Finding of Suitability to Transfer for Parcel A (Revision 3)

Hunters Point Shipyard
San Francisco, California

FINAL

October 14, 2004

FIGURE 2
PARCEL A MAP

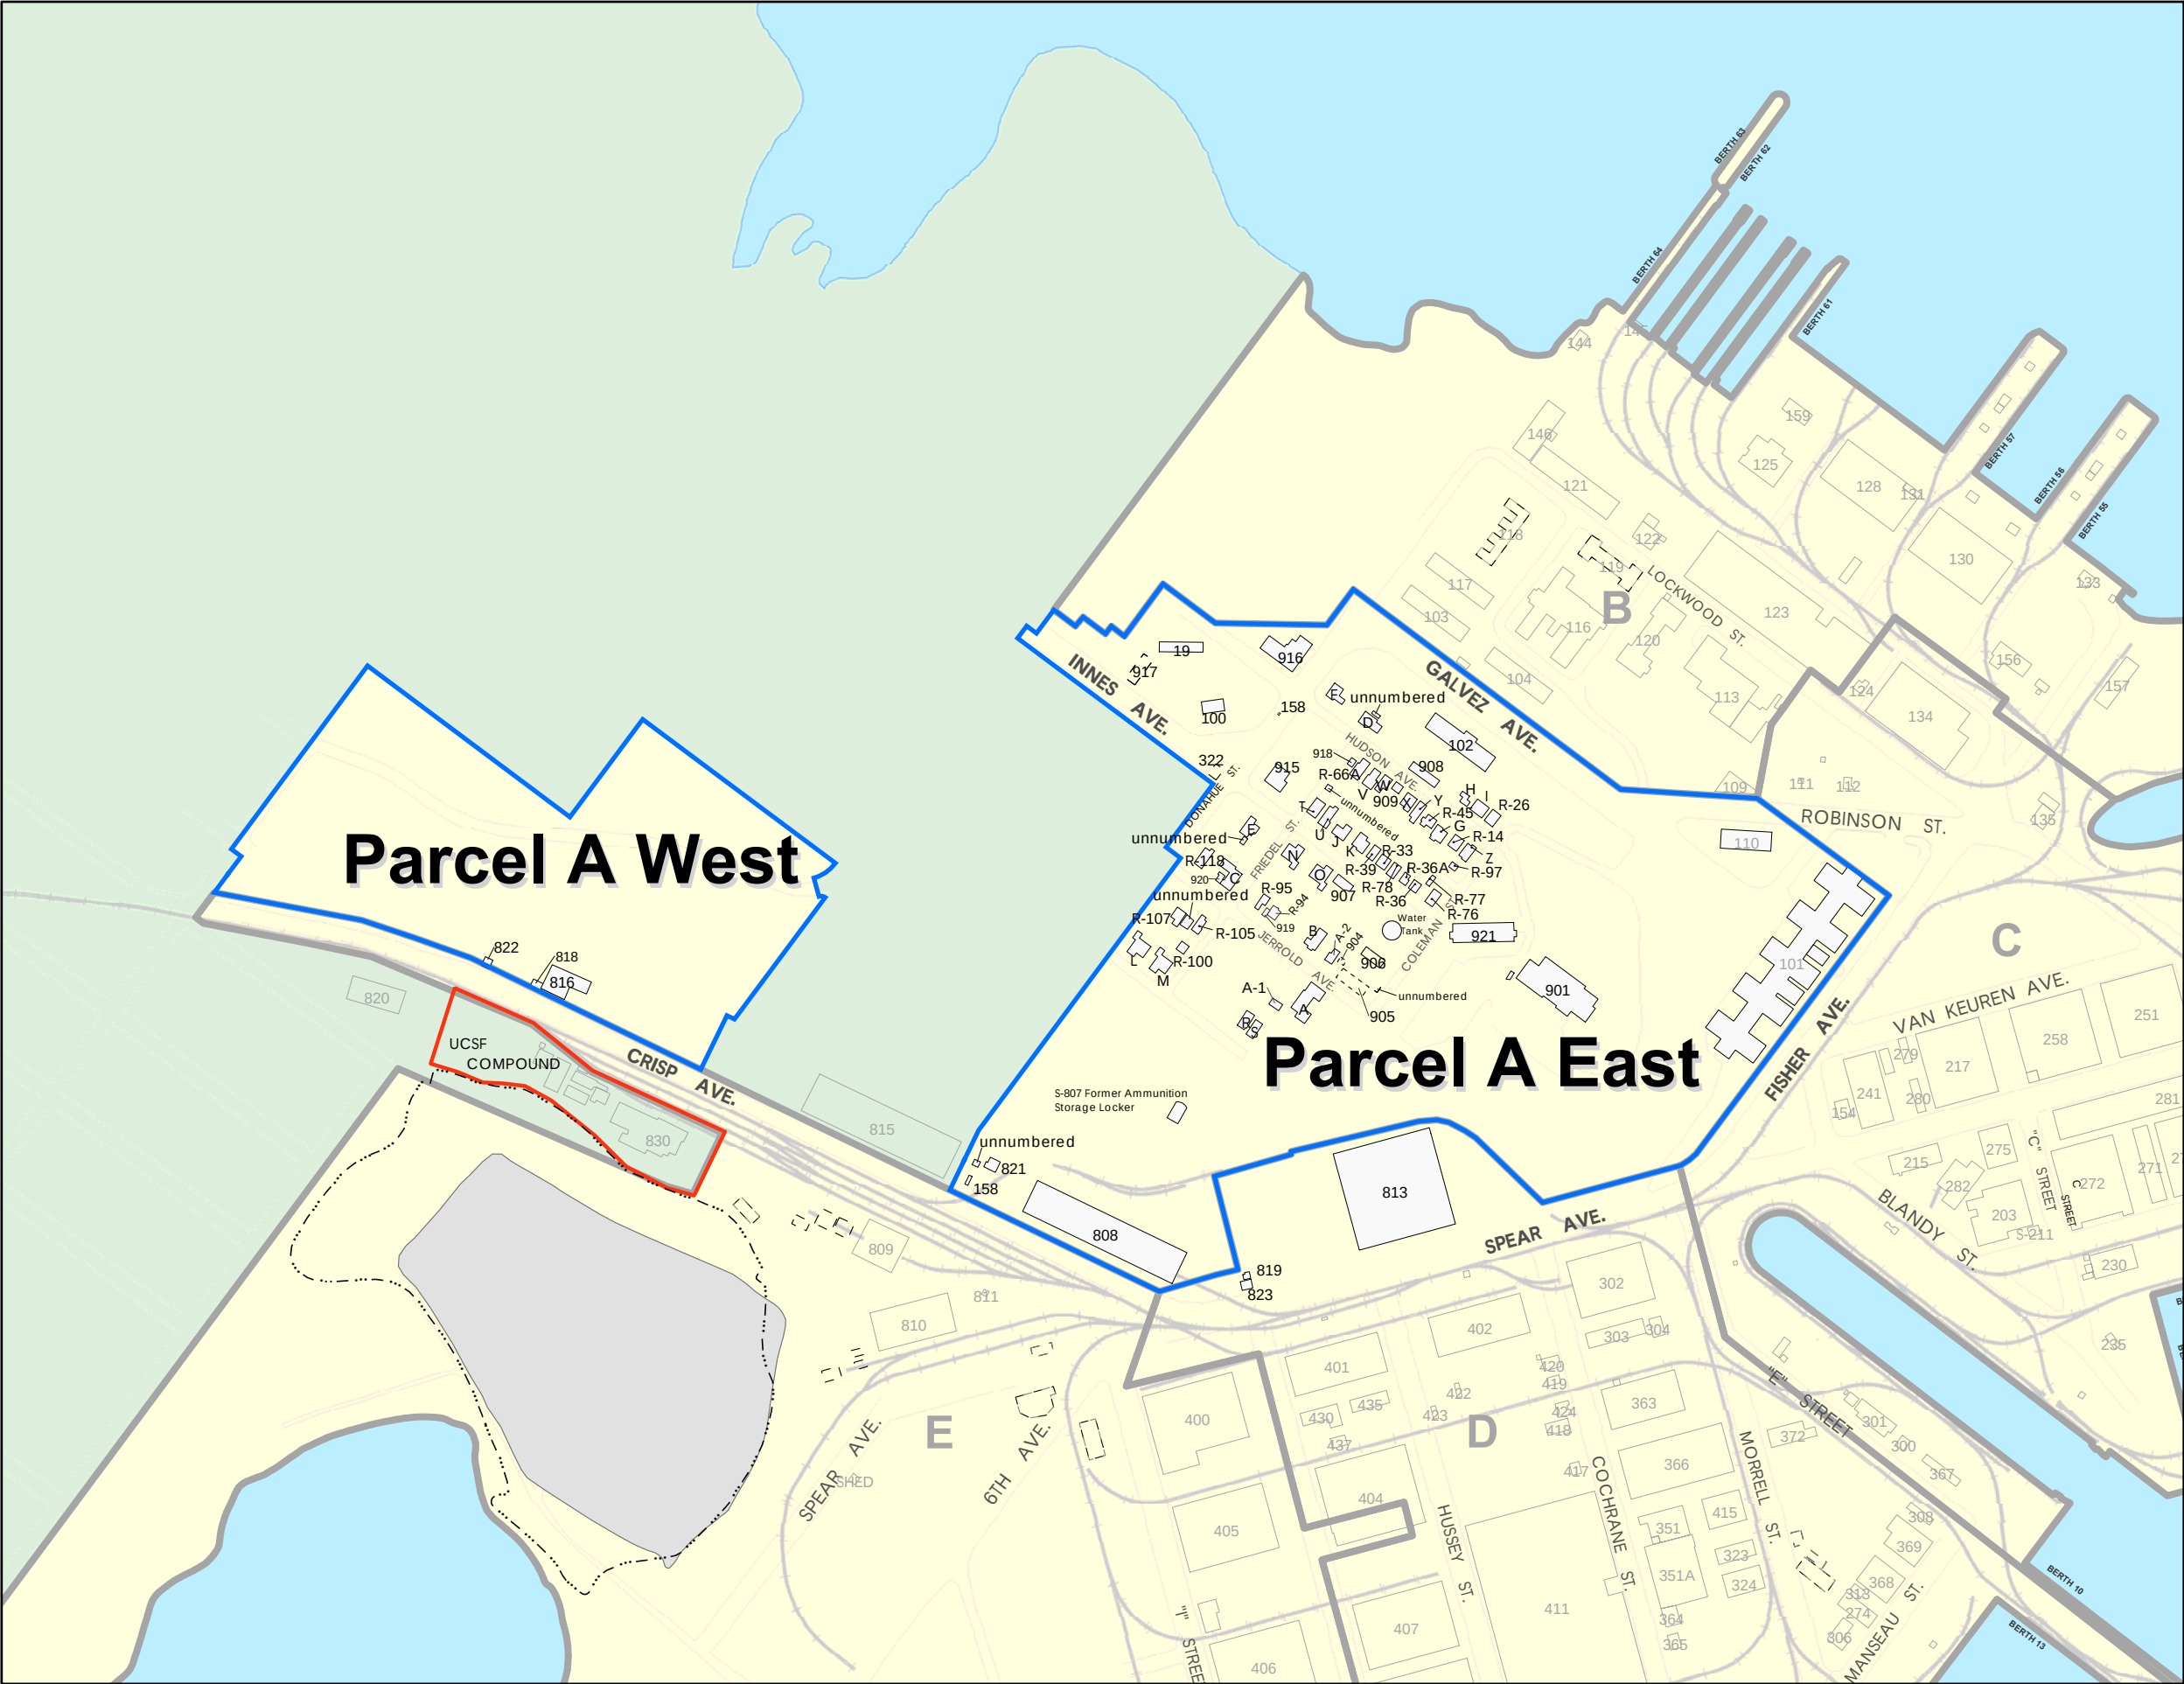
3. **Comment:** **Section 2.0 Property Description:** The text states that, “Currently, 64 buildings are present on Parcel A...” However, 70 buildings are shown on Figure 2. Also, the number of buildings on FOST Figure 2 does not agree with the number of buildings shown on ROD Figure 3: for example, three additional buildings in Parcel A West are shown on ROD Figure 3 and Building 818 is not shown. Please clarify the number of buildings that are included in this FOST (and which are on Parcel A).

19. **Comment:** **Figure 2:** Please include/label the following buildings (some of which are listed on Table 1): Building 158, R-66A garage, R-105, T garage, small unnumbered building adjacent to R-107, small unnumbered buildings adjacent to D and E, unnumbered building in H53, two small unnumbered buildings west of Building 821, and one small unnumbered building west of Building 901.

- a. Include transformer sites in S46A, H49, H53, H57 and electrical substations.
- b. H-49. Include R-106 and the building (Figure 2) adjacent to R-107. Also: R-105 is not shown/labeled on Figure 2.

- c. H-50. Include small building adjacent to E.
- d. H-51. Building 158 is not shown on Figure 2.
- e. H-53. Unnumbered residence not shown on Figure 2.

- f. H-54. R-66A and T garages are not labeled on Figure 2.
- g. HOS-A. The subparcel designation for Buildings F, 102 and 901 should be HOS-A (not H-OS) to be consistent with Figure 3.

Response: Based on map reviews and site observations, Figure 2 has been revised to show total of 72 existing buildings in Parcel A. Figure 3 of the ROD shows small structures north of Building 817 and west of Building 816 in Parcel A West, which are not shown on Figure 2 of the FOST. Based on interpretation of recent aerial photographs, Figure 2 of the FOST has been revised to show buildings in Parcel A West, including 816, 817, and 818. In addition, the number of buildings in the text in Section 2.0 has been revised to refer to a total of 72 buildings located within Parcel A, including the water tank.

Response: [Figure 2](#) has been revised to include labels for Buildings 158, R-66A garage (labeled as 918), R-105, and T garage (labeled as unnumbered). In addition, the following buildings were labeled as unnumbered: small buildings adjacent to R-107, D, E, 821, 901, and 905.

- a. A new column, Transformer Sites, has been added to [Table 2](#) to identify subparcels with transformer sites, as shown in the table below.
- b. [Figure 2](#) has been revised to change the label from “R-106” to “R-105.”

- c. The designation “unnumbered building” has been added for H50.
- d. [Figure 2](#) has been revised to show Building 158.
- e. [Table 2](#) has been revised to show the following buildings in H53: 904(d), 905(d), 906(d), 907, 919, A-2, B, N, O, R-94, R-95, water tank, and unnumbered storage cage. [Figure 2](#) has been revised to show the unnumbered storage cage.

- f. [Figure 2](#) has been revised to show a label for the T garage as “unnumbered” and a label for the R-66A garage as “918”. [Table 2](#) has been revised to reflect these changes in H54.

FIGURE 4 PARCEL A CERCLA SITES

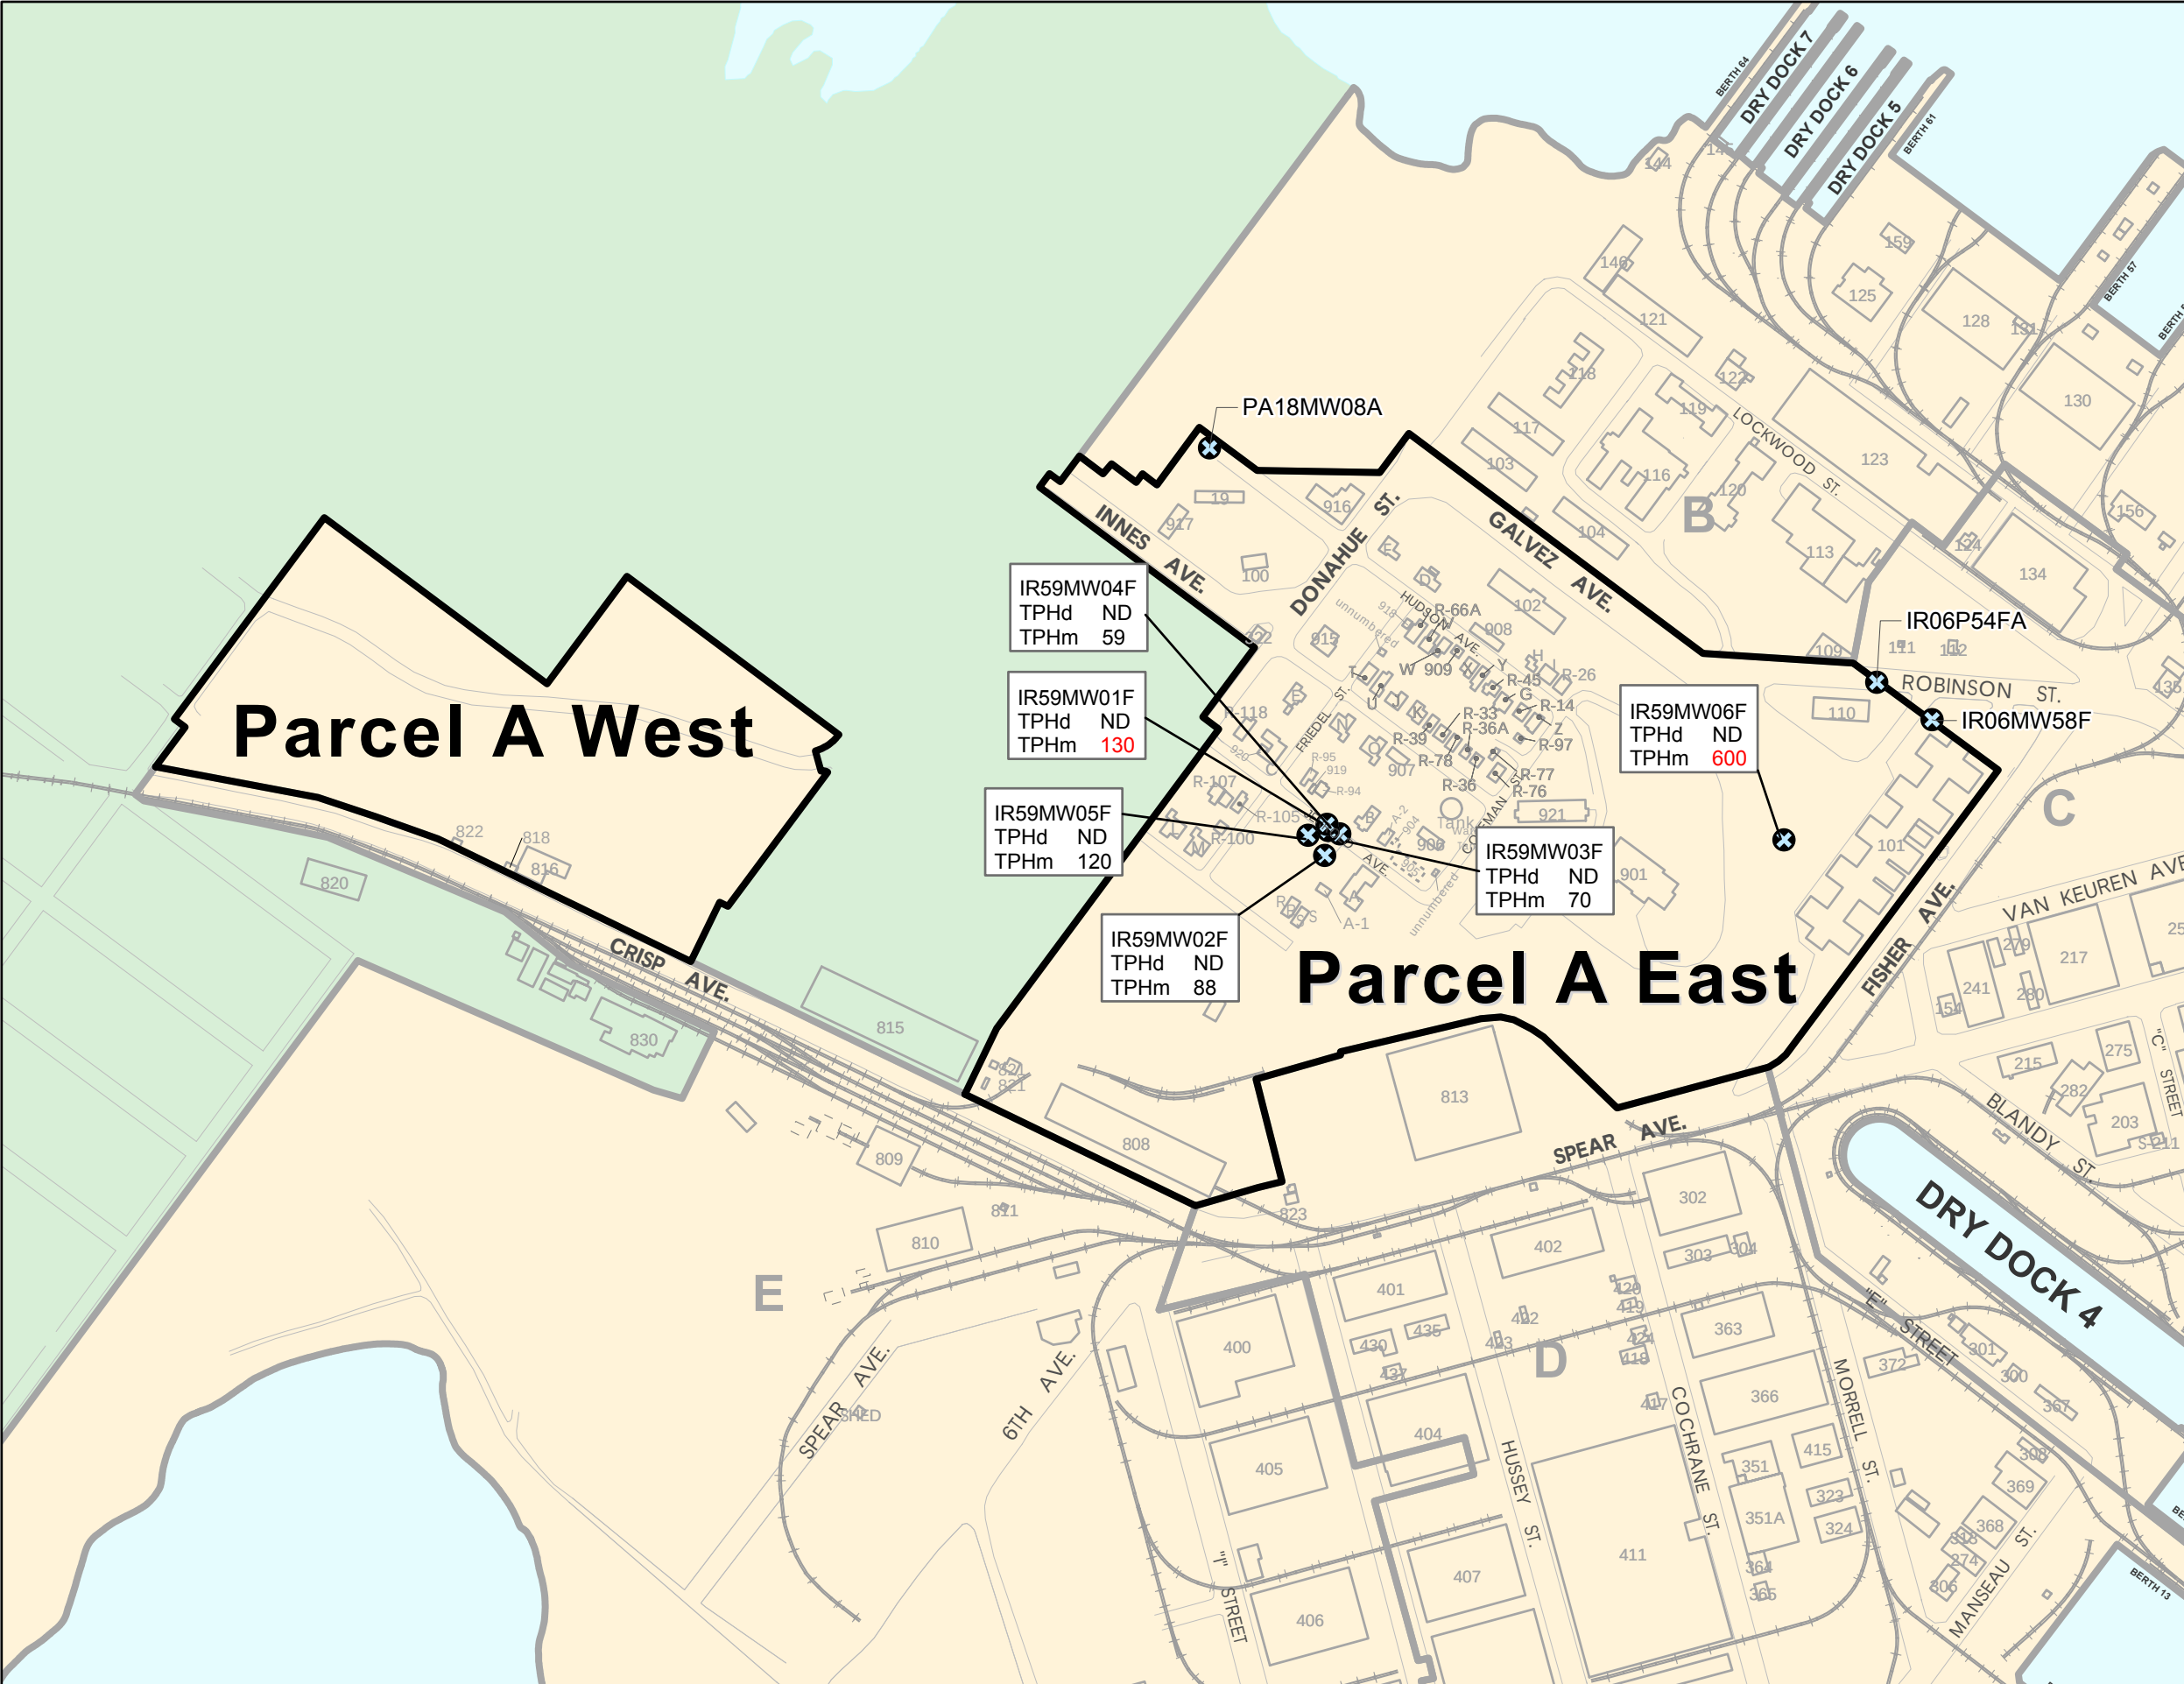
12. **Comment:** **Section 5.2.1. Polychlorinated Biphenyls:** Please ensure that the figure E1, Utilities Technical Study, Phase 2 Oil Containing Electrical Equipment Location Plan 1 from the October 19, 1990 report entitled, “Preliminary Assessment Other Areas/Utilities Naval Station, Treasure Island Annex, Volume II: Appendices” has been reviewed in preparation of this FOST. Some transformers on that figure (E1) do not appear on figure 4 of the FOST. Some examples include: an oil transformer at Building 101, two pole mounted transformers on Donahue Street and another pole mounted transformer at the south west end of Fredell Street.

20. **Comment:** **Figure 4:** Please include the date of the aerial photograph.

Response: Several sources have been reviewed to identify transformer sites in Parcel A. They include the basewide EBS (Tetra Tech EM Inc. [[Tetra Tech](#)] 1998), the Parcel A site inspection (SI) report (PRC Environmental Management, Inc. [[PRC](#)] 1993), and Figure E1, Utilities Technical Study, Phase 2 Oil Containing Electrical Equipment Location Plan 1, from the October 19, 1990, report, “Preliminary Assessment Other Areas/Utilities Naval Station, Treasure Island Annex, Volume II: Appendices” (Harding Lawson Associates [[HLA](#)] 1990). Test results for the oil-containing electrical equipment appear in Tables 4-1 and 4-2 of Appendix D in the preliminary assessment report ([HLA](#) 1990). Two pad-mounted transformers east of Building 100, labeled as V4 and V5, are non-PCB-containing equipment. One pole-mounted transformer on Donahue Street, labeled P400, is non-PCB equipment. Another pole-mounted transformer is located outside of Parcel A. Test results for two oil switches and two oil fuse cutouts located at Building 101—labeled GH116, GH119, GH117, and GH118—are all non-PCB bearing. Thus, the FOST should not present these items as transformer sites. Locations of other oil-containing electric equipment are consistently shown in Figure E1 of the preliminary assessment report and [Figure 4](#) of the FOST.

Response: The date of the photograph (2000) has been included on [Figure 4](#) of the revised FOST.
